From: [Peter Tonkes](#)
To: [Maurice Sheehan](#)
Cc: [Neil Beck](#)
Subject: RE: Proposed Subdivision - Lot 2 on SR 431, Craiglie.
Date: Wednesday, 19 February 2020 4:19:27 PM
Attachments: [image001.png](#)
[image002.png](#)
[image003.png](#)
[image004.png](#)
[image005.png](#)
[image006.png](#)
[image007.jpg](#)

Subject: RE: Proposed Subdivision - Lot 2 on SR 431, Craiglie.

Subject: Proposed Subdivision - Lot 2 on SR 431, Craiglie.

Councils reference number for the Operational Works Application is 2019_3370/1.

1. FOR SCOUR ARRANGEMENT REFER WSA DWG. SPS-1602
2. FOR GAS RELEASE ARRANGEMENT REFER WSA DWG. SPS-1602 EXCEPT SCOUR INVERT TEE INVERTED.

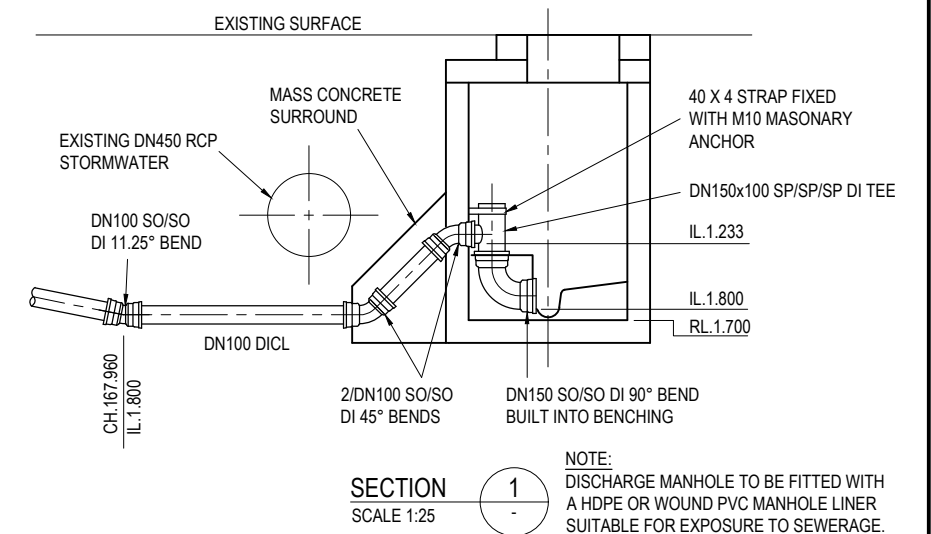
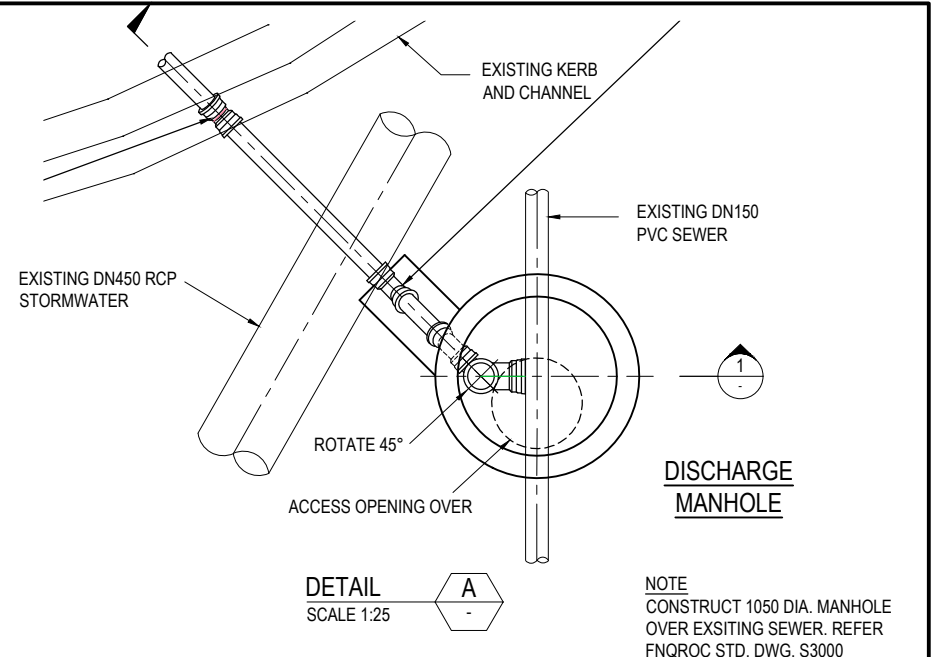
- Specify Flygt pumps, Siemens flow meters, Schneider VSD
- At the scour points on the rising main are there pits? Not apparent on the drawings. Also prefer air release in a pit for function and serviceability.
